INCREASED STORM DRAIN INFLOWS TO BAKER CREEK = INCREASED RISK OF FLOODING CRESTBROOK

RECEIVED

APR 10 2019

COMMUNITY DEVELOPMENT
CENTER

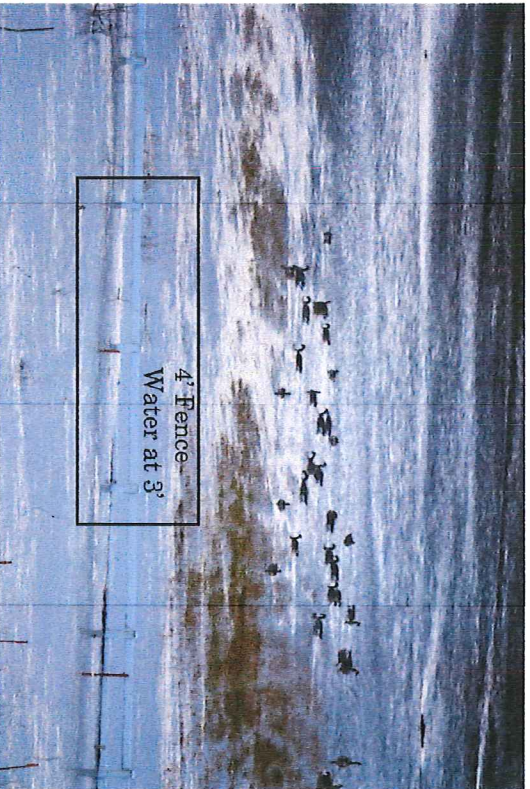
- * Crestbrook in background
- * far side of fence is 500 year floodplain
- * area from fence to camera is only rated wetlands
- * Both areas have flooded equally 3 times in 5 years

- * Who determined wetlands or floodplain? They are both the same depth.
- * Wetlands have flooded 3 times in 5 years. Needs re-classifying.

Approximate location of midigated area.

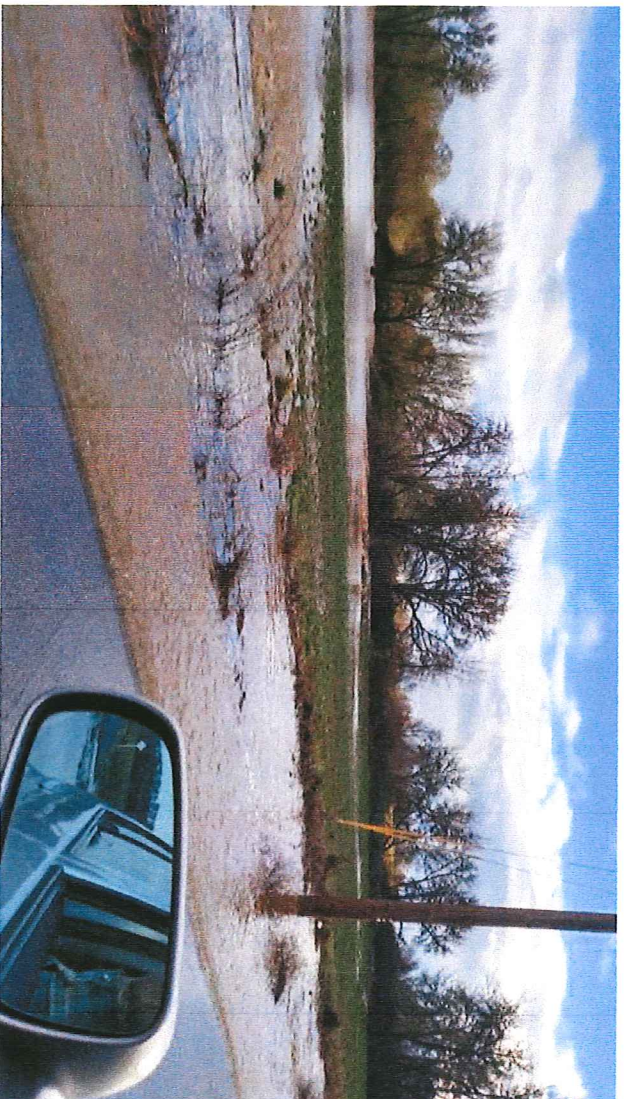
- * This angle shows how close flood aers come to Crestbrook
- * Water well up on Toth's goal posts

2015 Flooding on Stafford Property from Baker Creek Road

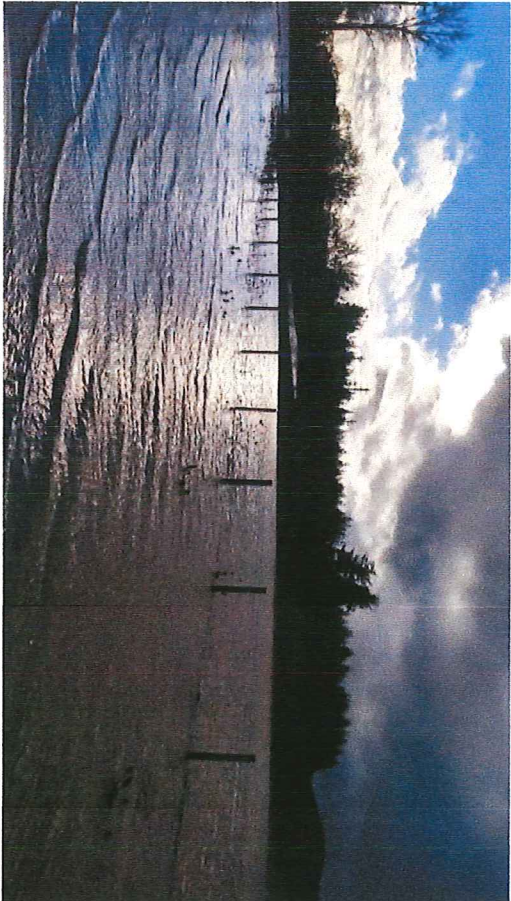
- * Refer to FEMA upstream picture - there is a lot of water that comes down from upstream.
- * Also, this shows another 100 acres (Staffords and Premiers) where storm drainage will be directed to the wetlands.

2015 Flooding at Baker Creek Rd. & Hill Rd.

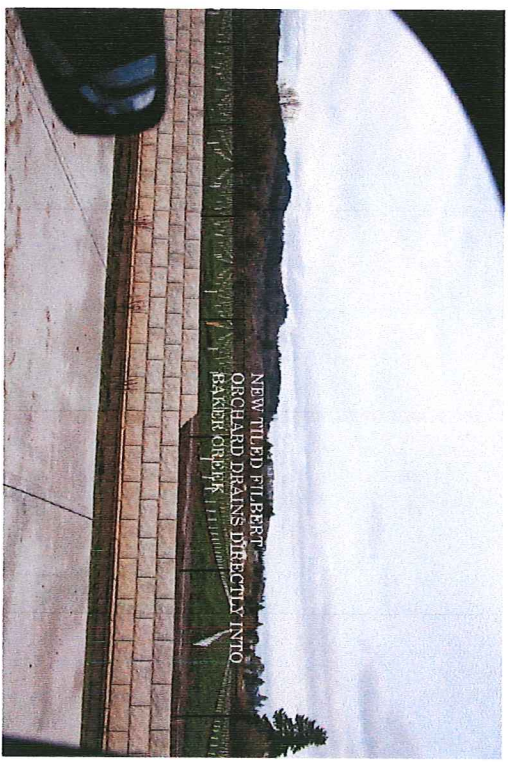
*With Hill Road project and Baker Creek East/West developments, was this storm water directed to the Baker Creek Drainage Way?

* To avoid flooding in Crestbrook, 100% of the wetlands needs to be preserved.

*If filling/diking wetlands is allowed, and 100 more acres developed (Oak Ridge Meadows & Stafford's Northside property, Crestbrook could flood with less than 2" of rain.

December 2018

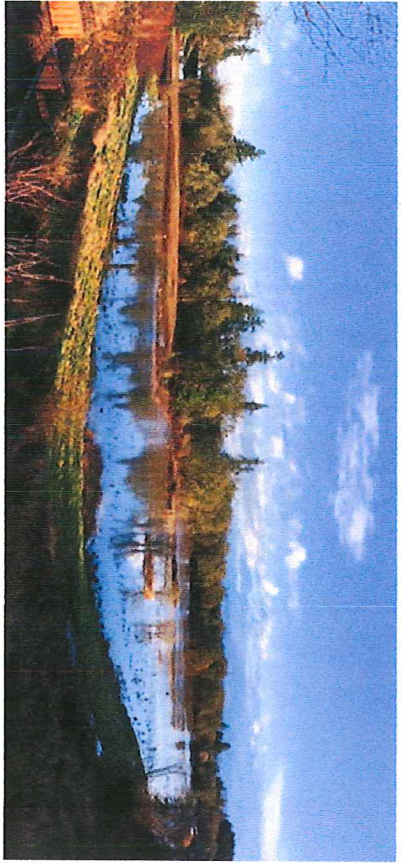
*What once took a heavy rainfall to produce flooding in the wetlands, now takes one decent rain storm. Pretty common in Oregon year round.

*Different angle that doesn't show lower Crestbrook as well but almost as high as December 2015 flood.

*Again, wetlands and 500 year floodplain flooded at the same level

*Water at left of picture is approximately where Premier is proposing a dam/intake(?) structure. Exhibit 7. It looks like its purpose is to divert flood waters 50 yard eastward, so they could build a cul-de-sac and six more houses. BUT this will just result in decreasing size of wetlands so risk of flooding Crestbrook increases even more.

Exhibit 7

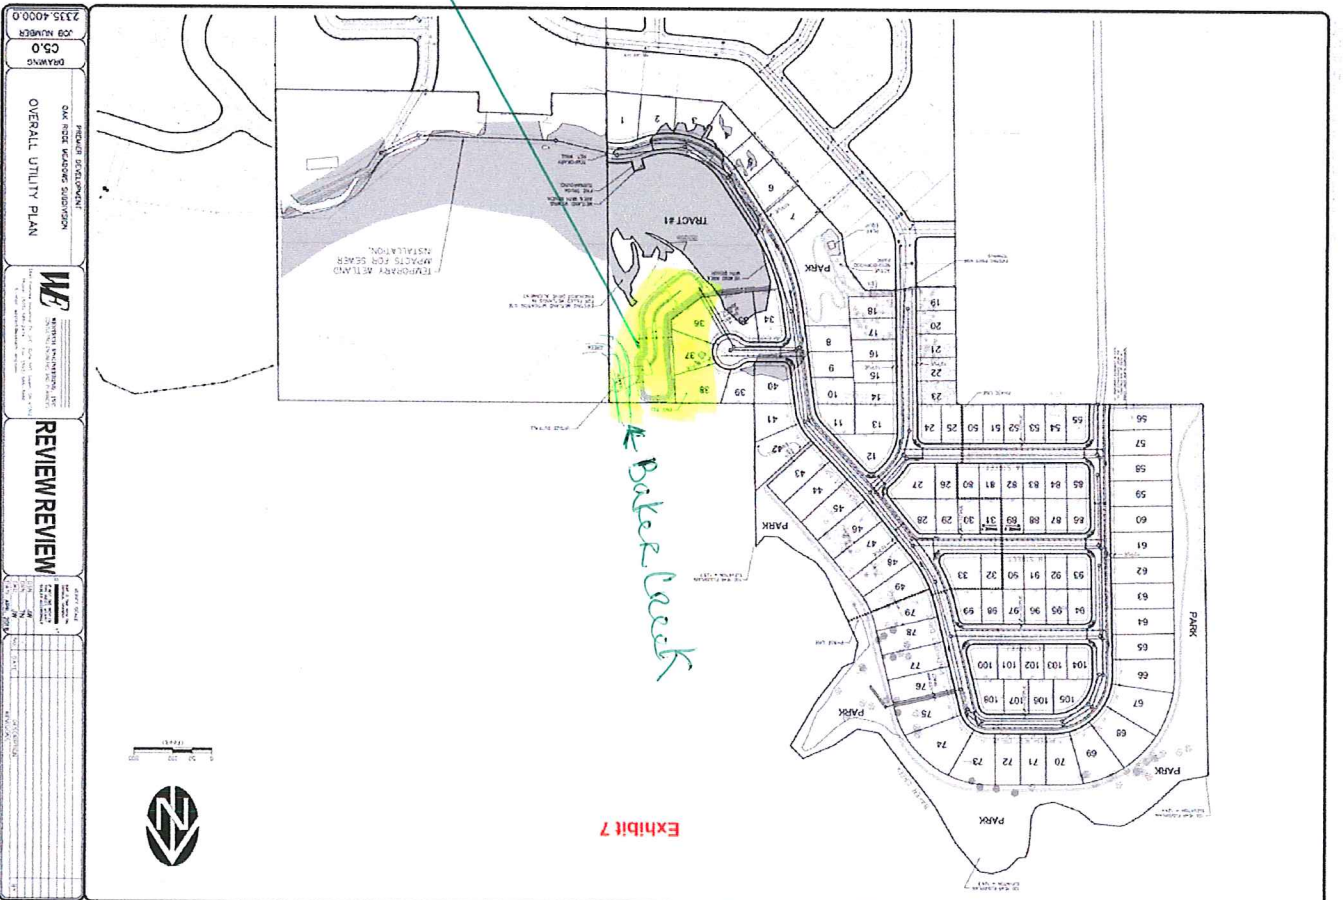
Engineered dam/intake(?) to divert more floodwater down stream and make 5-6 more lots possible.
 WHAT ABOUT Crestbrook?
